Response to the Department of the Navy's Letter on: Assessment of ATSDR Water Modeling for Tarawa Terrace

March 10, 2009

RESPONSE TO THE DEPARTMENT OF THE NAVY'S LETTER ON ASSESSMENT OF ATSDR WATER MODELING FOR TARAWA TERRACE

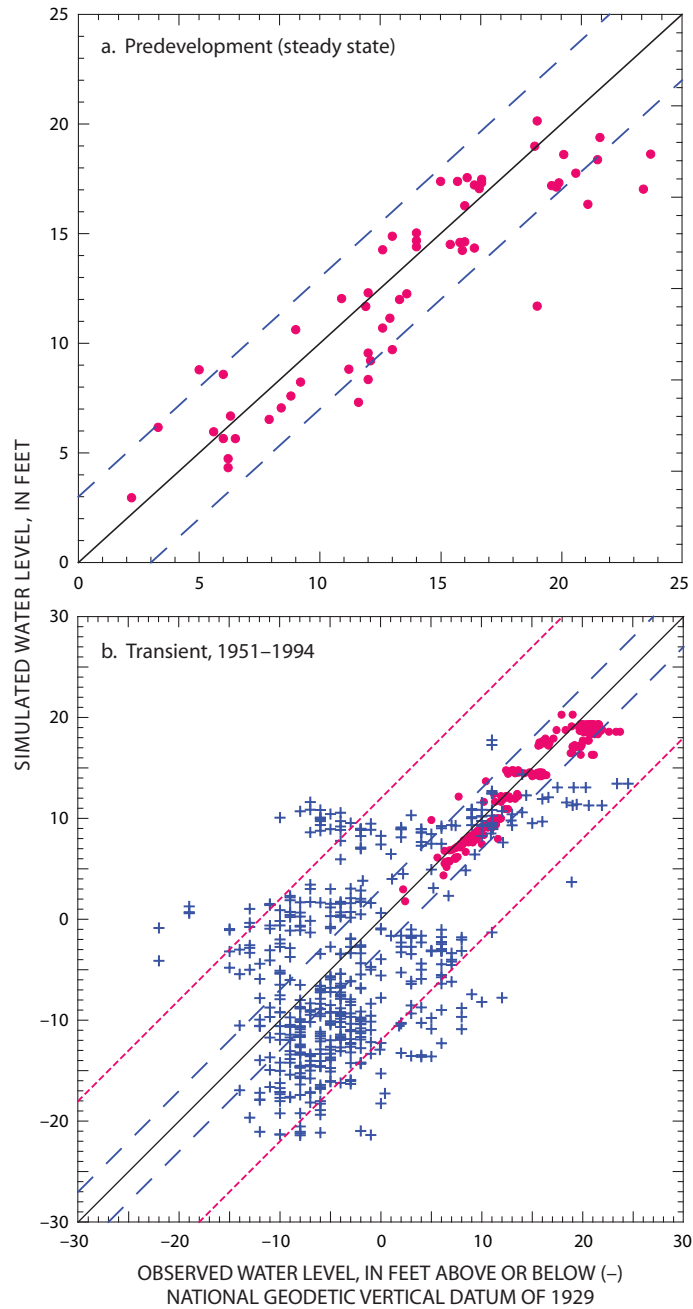
For Tarawa Terrace groundwater, the difference between observed and simulated elevations is 5 to 10 feet at many times during the 1970's and 1980's. This is a significant disparity because the total change in groundwater elevation from the source area to the receptor wells is approximately 10 to 12 feet.

This DON approach to evaluating model calibration applies a generalized “rule of thumb” to the Tarawa Terrace groundwater-flow models and is possibly based on wording found in ASTM Guide D5981-96, Standard Guide for Calibrating a Ground-Water Flow Model Application, (ASTM 1996, section 6.4.1): *“the acceptable residual should be a small fraction of the difference between the highest and lowest heads across the site.”* ATSDR is not in agreement with this approach to evaluate model calibration. A careful review of ASTM D5981-96 in its entirety indicates that the DON’s comment, as stated, is totally removed from the context of Section 6 of the ASTM Standard Guide as well as the context of the accuracy of field data used to calibrate the Tarawa Terrace groundwater-flow model, as described in the Chapter C report (Faye and Valenzuela 2007). For example, in Section 6.4, ASTM D5981-96 states: *“the magnitude of the acceptable residual depends partly upon the magnitude of the error of the measurement or the estimate of the calibration target and partly upon the degree of accuracy and precision required of the model’s prediction.”* Furthermore, Note 2 of ASTM D5981-96 states: *“Acceptable residuals may differ for different hydraulic head calibration targets within a particular model. This may be due to different errors in measurement.”* The Tarawa Terrace Chapter C report (Faye and Valenzuela 2007, p. C24) provides a comprehensive discussion of water-level measurement errors arising from the use of airlines and pressure gages to measure water levels. Faye and Valenzuela also point out that this is consistent with the discussions of LeGrand (1959) who described problems associated with the use of airlines to measure water levels at Camp Lejeune as far back as 1959. As pointed out in Faye and Valenzuela (2007, p. C24): *“Typically, reported water levels [at supply wells] vary in excess of 20 ft during the period of measurement, and frequently 10 ft or more from month to month.... Such variability also may indicate leaking or damaged airlines or pressure gages.”*

Faye and Valenzuela (2007, p. C24) also provide detailed discussions as to the rationale for selecting two calibration target ranges for the transient groundwater-flow model. At wells where water-level measurements were obtained using airlines and pressure gages, the calibration target was selected as an absolute difference of 12 ft between simulated and measured water levels. This target was based on well-known disadvantages of using pressure gages and airlines to obtain accurate water-level measurements. Where water-level measurements were obtained using the more highly accurate tapes and similar devices at monitor wells, the calibration target was selected as an absolute difference of 3 ft between simulated and measured water levels. This target was based on the least accurate of these water-level measurements where topographic maps were used to estimate the altitude of a measuring point.

Evaluating model calibration using the “rule of thumb,” as the DON has suggested, also assumes that no other information is available to determine calibration targets. When information is available, such as direct knowledge of methods of water-level measurements and information characterizing the measurement device(s), the calibration targets should be based on these data, not on a “rule of thumb.” Faye and Valenzuela (2007) provide detailed listings of measured water levels in supply and monitor wells throughout Tarawa Terrace (Appendix C5).

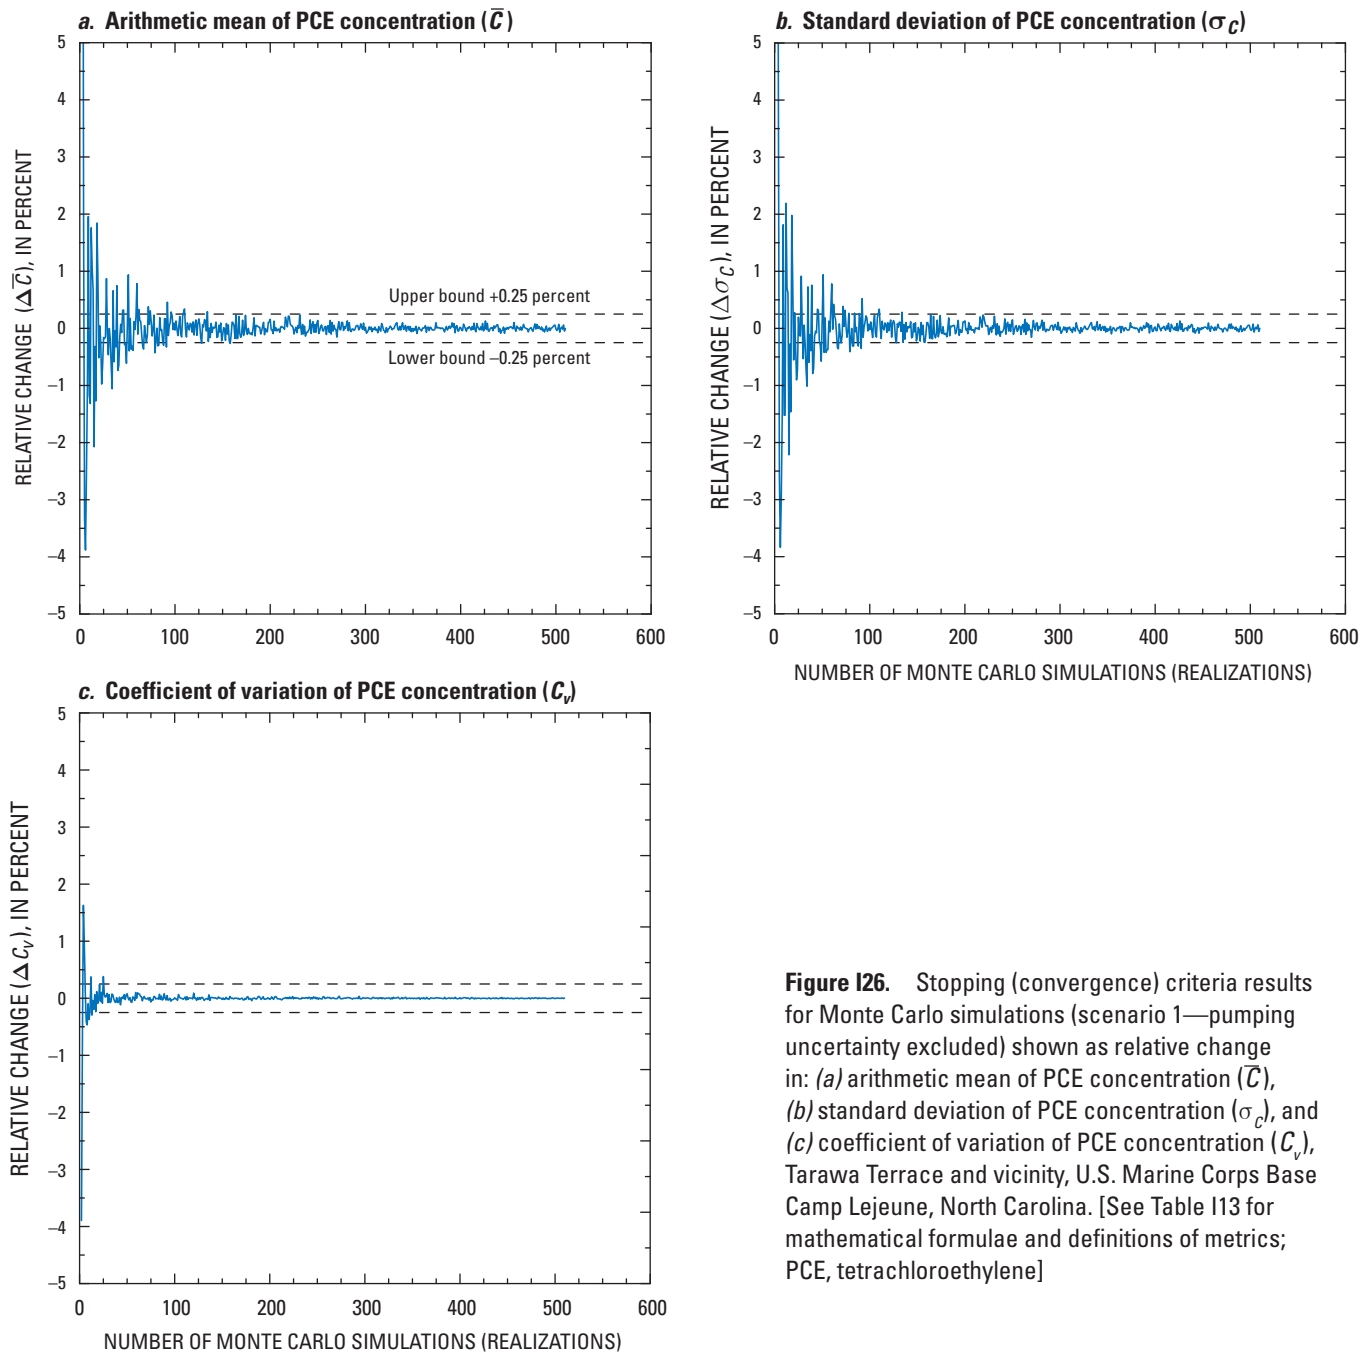
... certain combinations of input parameters resulted in wells drying out, so only 510 physically viable realizations were produced. Thus, 330 out of 840 realizations were not viable, raising concerns about the representativeness of the input parameter distributions.

The issue that should be addressed is not how many realizations produced physically plausible solutions, but rather, are the 510 realizations that were successfully produced sufficient to represent an infinite number of random solutions? The metric that determines whether or not this question is answered in the affirmative is the relative change in stopping criteria between successive model simulations. If this relative change is small within a predetermined range, then additional simulations are redundant and do not statistically contribute to an improvement of the representativeness of the overall results with respect to the statistical distributions. The Chapter I report (Maslia et al. 2009) describes in detail the criteria used to determine when a sufficient number of realizations have been achieved. Three stopping criteria were used to halt the Monte Carlo simulation: (1) relative change in the arithmetic mean of PCE concentration in finished water at the Tarawa Terrace WTP, $\Delta\bar{C}$; (2) relative change in the standard deviation of PCE concentration in finished water at the Tarawa Terrace WTP, $\Delta\sigma_c$; and (3) relative change in the coefficient of variation of PCE concentration in finished water at the Tarawa Terrace WTP, ΔC_v . Mathematical formulae and definitions of the aforementioned stopping criteria metrics are listed in Table I13 of the Chapter I report (Maslia et al. 2009). In applying the stopping criteria to the Monte Carlo simulations, an upper and lower bound of $\pm 0.25\%$ was used for each metric. When the computed relative change ($\Delta\bar{C}$, $\Delta\sigma_c$, and ΔC_v) was within the aforementioned bounds and the total number of realizations was 500 or more, the Monte Carlo simulation process was halted. Examples of the stopping criteria for each metric are shown graphically in Attachment 8 (Maslia et al. 2009, Figure I26). As can be seen from the stopping criteria, insignificant change (much less than 2.5%) occurs after 300 realizations. Therefore, 510 realizations were more than sufficient to represent an infinite number of random solutions.
